**RE: Matunuck Beach Condos  
AP 92-2 Lot 56  
South Kingstown, RI**

RHODE ISLAND COASTAL RESOURCES MANAGEMENT COUNCIL  
REPORT OF FINDINGS -- PRELIMINARY DETERMINATION

**NAME:** Eileen Biancuzzo      **CRMC FILE NO.** D2019-03-087  
**LOCATION/POLE:** Matunuck Beach Road  
**CITY/TOWN:** South Kingstown      **PLAT:** 92-2      **LOT:** 56

**PLAN(S) REVIEWED:** "Site Layout Plan, Matunuck Beach Road Condos, AP 92-2, Lot 56, South Kingstown..." as last revised 3/21/19 by DiPrete Engineering.

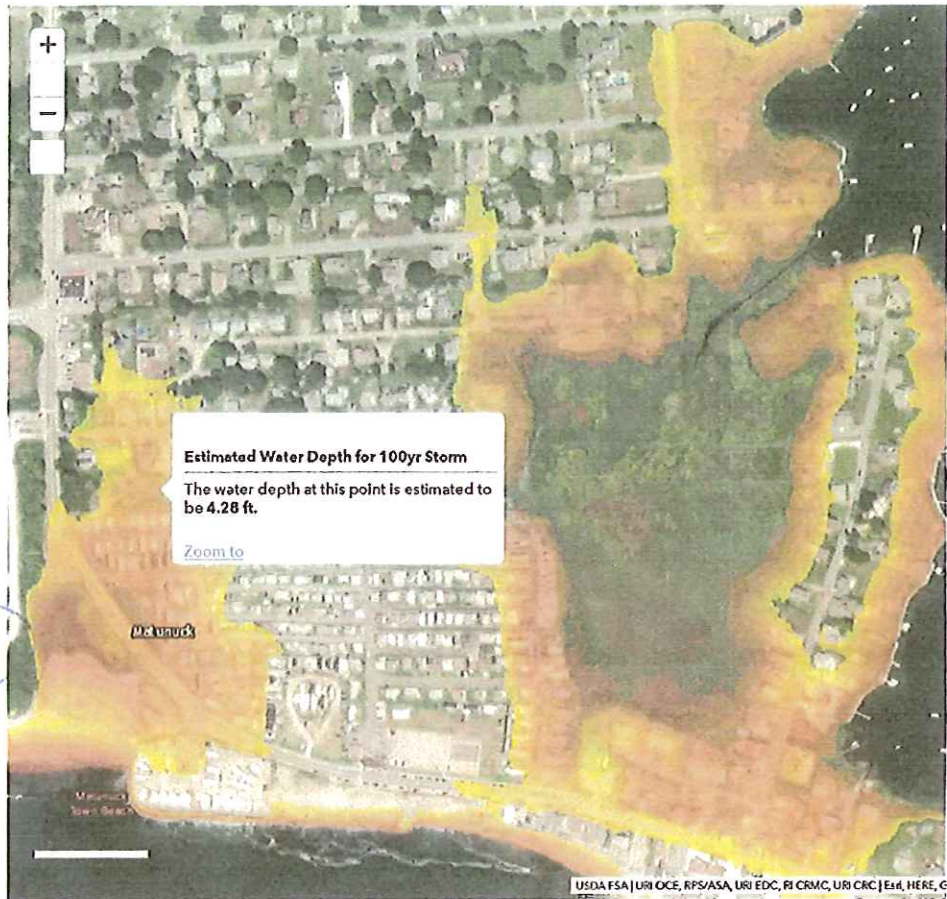
11) Lastly, the applicant shall address Section 1.3.1(A) as well as Section 1.1.10 of the RICRMP and review the attached Stormtools mapping projections for this site under various future sea level rise scenarios. Additionally, the SLAMM maps available on CRMC's website shall be utilized in formation of this project design, as the adjacent coastal wetland is one of the largest along this waterbody.

**Site Layout Plan  
Matunuck Beach Road Condos**

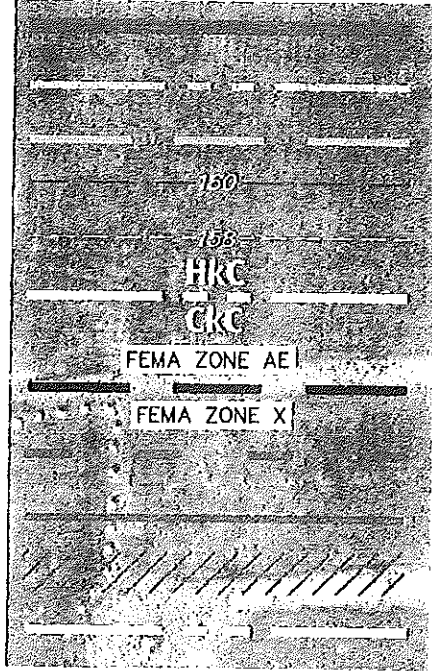
- 1) Staff walked the project site primarily along the southern mowed path and noted the coastal feature to be the contiguous freshwater wetland associated with the coastal wetland/salt marsh complex located in the southwestern corner of Potter Pond to the east. Future Assent submittal shall have the wetland edge delineated in the field as well as on site plans.

- 3) The RICRMP requires a 200' buffer zone for parcels >200,000sf adjacent to Type II waters, as measured inland from the coastal feature. The lot can easily accommodate this requirement although portions of the proposed project may need to be reconfigured.

- 4) The RICRMP also requires a 225' construction setback for all filling, grading and construction activities as measured from the inland edge of the coastal feature. The lot can also accommodate this requirement although portions of the proposed project may need to be reconfigured.

- 6) The RICRMP requires the treatment of stormwater runoff for all new impervious areas including residential rooftops. Low Impact Development techniques consistent with the state Stormwater Manual such as pervious driveways and reduced roadway dimensions shall be utilized for this site.

- 7) The Salt Pond SAMP Land Classification requires the installation of denitrification septic systems for this site, consistent with RIDEM requirements as well. A Subdivision Suitability shall be provided at the time of Assent application as well as applicable local approvals.

Management plan. A conservation easement shall be placed on the entirety of the buffer zone and coastal feature as part of any CRMC approval and additional areas of vegetated open space should be preserved throughout the development. Buffer zone management such as shoreline access path shall be addressed in the proposed plans, as applicable.

12) The lot is able to support residential development at this time, however reconfiguration in accordance with the above requirements is necessary to be consistent with CRMC programmatic concerns. Any standards not met shall be accompanied by a written variance request (ref. Sec.1.1.7) at the time of future application.
